CITY OF MINNETRISTA

REQUEST FOR CITY COUNCIL ACTION

Subject: Application from J & J Minnetrista, LLC (Mackenthun's) for concept review of a grocery store and multi-family apartment building on property located within the Woodland Cove Master Planned Unit Development.

Re: Mackenthun's Development
Concept Plan Review – Revised July 12, 2022
ML No. 22018

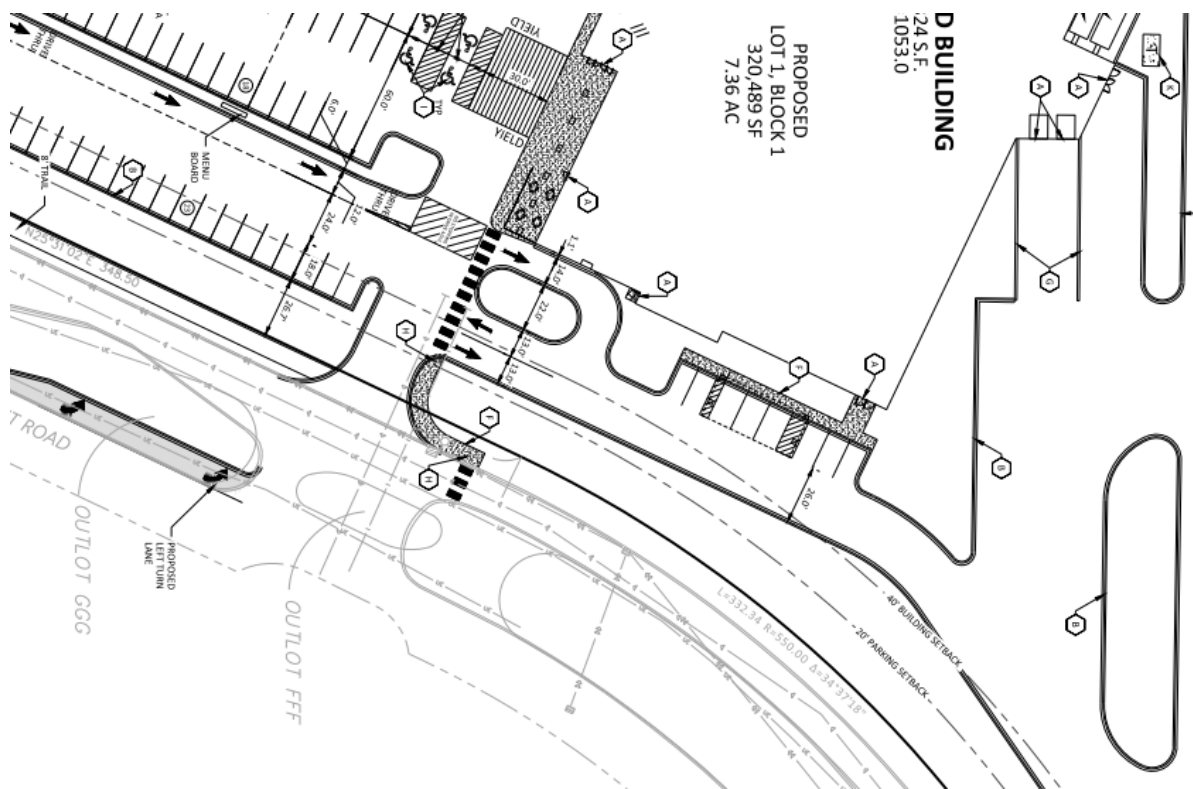
- d. Option #4 – Grocery storefront aligns with Woodland Cove Blvd intersection within King's Point Road (current, proposed layout):
 - i. South-facing storefront is best practice for grocery store design.

- ii. This layout allows for the optimum location for the grocery storefront aisle/drive, aligned with Woodland Cove Blvd on the East side of King's Point Road.

- iii. Allows for use of existing curb cut in King's Point Road across from Cranesbill Road for ingress/egress for North private drive.
 - iv. Allows for use of existing curb cut in King's Point Road for ingress/egress for South private drive.

- v. Allows for delivery vehicle movements to access grocery unloading areas, as well as for delivery vehicle movements for ingress/egress at North site access point from King's Point Road.

- vi. Creates outlots for residual commercial users along North property line:
 - 1. 0.66-acre outlot parcel to be dedicated to the City of Minnetrista for the potential, future fire station.

- 2. 2.19-acre outlot parcel to for one or more potential commercial users.
 - vii. Allows for two access points to the multi-family site – (1) from the North private drive and (1) from the South private drive.

- viii. A pylon/monument sign near the South private drive will help draw attention to the Mackenthun's storefront from HWY 7 and Kings Point Road.

3. Circulation at East side of grocery store:

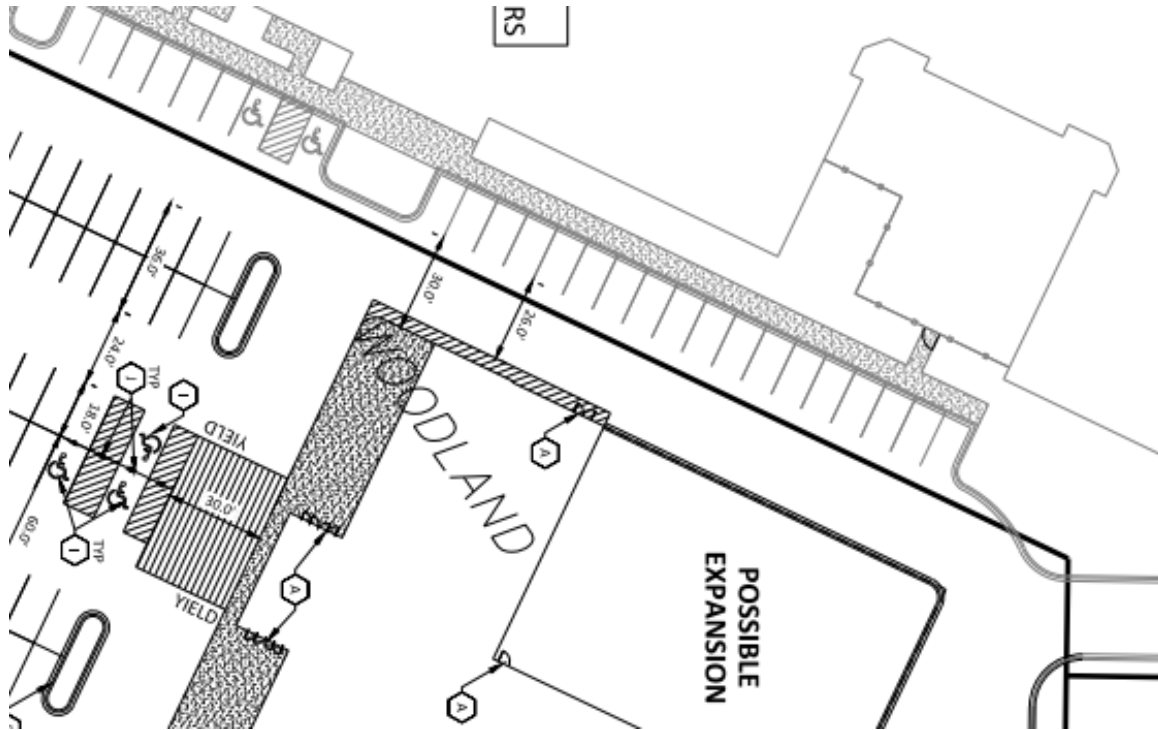
- a. See below for a revised site layout for East side of grocery store:

- i. Parking row along King's Point Road is eliminated to create additional circulation space, as well as reduce potential congestion.
- ii. Revised drive-thru egress layout for Caribou Coffee drive-thru.
- iii. Revised, defined separation of the Caribou Coffee drive-thru and online parking pick-up parking area.
- iv. Revised curb-line at loading dock/delivery area for improve delineation of delivery circulation.

4. Wine & Spirits deliveries/apartment parking coordination:

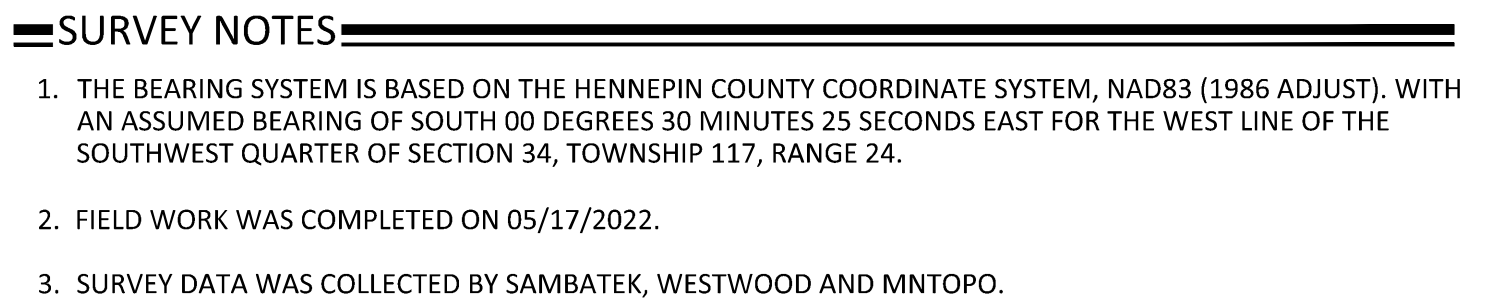
- a. See below for a revised site layout for the Wine & Spirits deliveries at the West side of grocery store.

- b. The width of the access drive West of the grocery store is 26', with an additional 4' striped area adjacent to the building for pull-off for wine & spirits' delivery vehicles.
- c. This layout is effective for allowing access of delivery vehicles as well as allowing ingress/egress for apartment parking stalls West of the grocery store.
- d. Wine & Spirits anticipated delivery stats:
- Anticipated quantity of delivery trucks per day – (1).
 - Anticipated timing of delivery each day – mid-morning.
 - Typical type of truck delivering product – semi-truck.
 - Typical method to unload delivery truck? – 2-wheeled carts.
 - Typical timeframe to unload a truck? – (1) hour.

CONCEPT WITH AERIAL

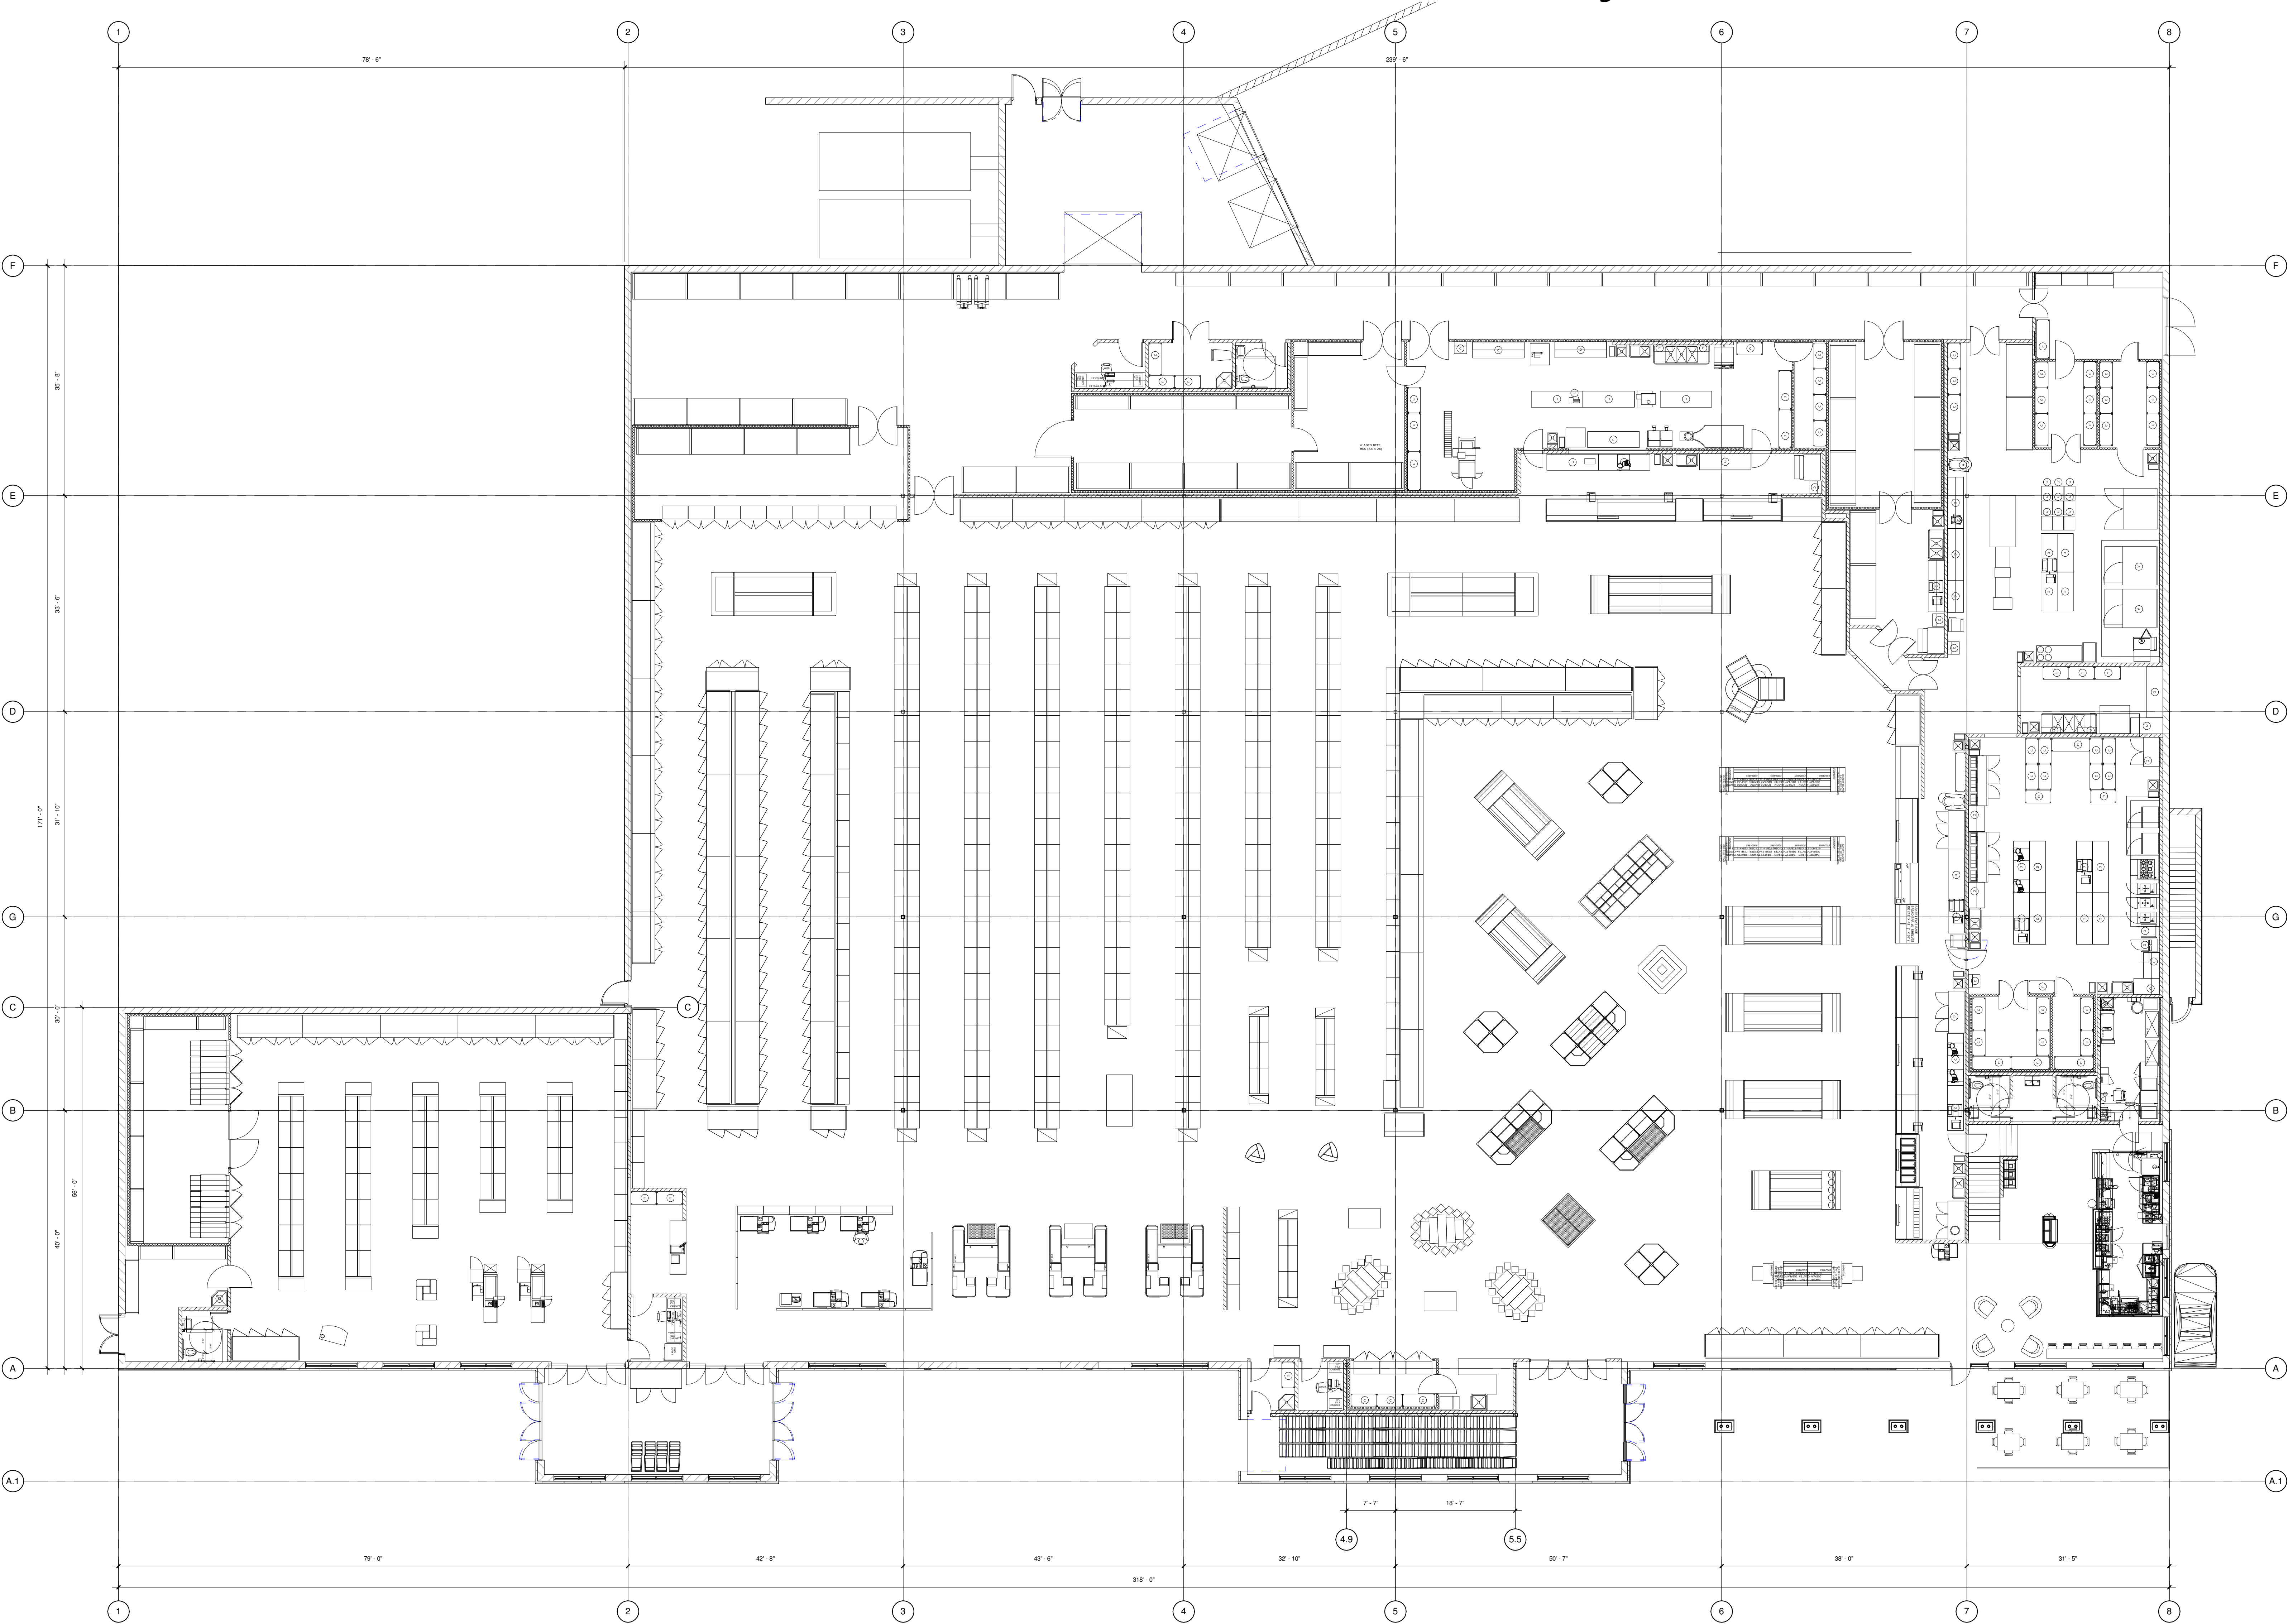
1. The proposed site grade is consistent with the surrounding grades and appears to be acceptable from a drainage standpoint.
2. The finished floor elevation (FFE) of the proposed residential building is 1054. This may result a large amount of fill, or will necessitate a large retaining wall, behind (north and west of) the building.

1. The design appears to allow for adequate circulation of vehicles, with residents of the residential building accessing through a dedicated private street directly to the underground parking garage.
2. 162 parking spaces are required per City Code for the grocery store, and 283 are provided. 7 spaces are dedicated as Americans with Disabilities Act (ADA) compliant, which meets the required amount.

3. 210 parking spaces are required per City Code for the residential building, and 228 are provided. 2 spaces are dedicated as ADA compliant on the surface level parking. The Applicant will be required to provide an adequate number of ADA compliant parking within the parking garage.
4. The developer shall provide information including determining trip generation calculations for ADT, AM peak and PM peak, and identifying what roadway improvements (if any) are recommended (e.g. restriping, installation/extension of turn lanes, traffic control needs).

- a. Verify the impervious area in proposed subcatchment O3. It appears that this includes the part of Kings Point Drive that drains to the existing sediment basin (existing node 3B, proposed node 3P). It appears this should be at least 0.6 acres of impervious area and was included as part of the impervious in existing subcatchment node 3BBID.

- b. Proposed subcatchment 9S should include the parts of Kings Point Drive and TH 7 that drain to the existing infiltration basin via the storm sewer. It appears this is approximately 2 acres, the majority of which is impervious. It appears that the southern part of the offsite area east of Kings Point Drive (existing node 100A, proposed node 103P) is drained through this storm sewer as well and should be routed to 2P. Ensure that 2P is sized appropriately for the entire drainage area.

- c. On future submittals, please include the rate control analysis by discharge point.
 - d. We do not recommend 12% slope on the culverts between 4P and 1P. The maximum allowable velocity into a pond is 8 fps. For pipes with slopes above 8%, tie all joints.

- e. It appears that device #3 for Pond 2P is the 48" grate of the OCS. This should be modeled as a horizontal grate rather than vertical.
 - f. Verify the time of concentration for proposed node 5S. 51 minutes appears too long. At a minimum, it should not be longer than the existing conditions time of concentration for 4AA.

- g. We recommend a minimum time of concentration of 7 minutes (existing node 100AA, proposed node O4).
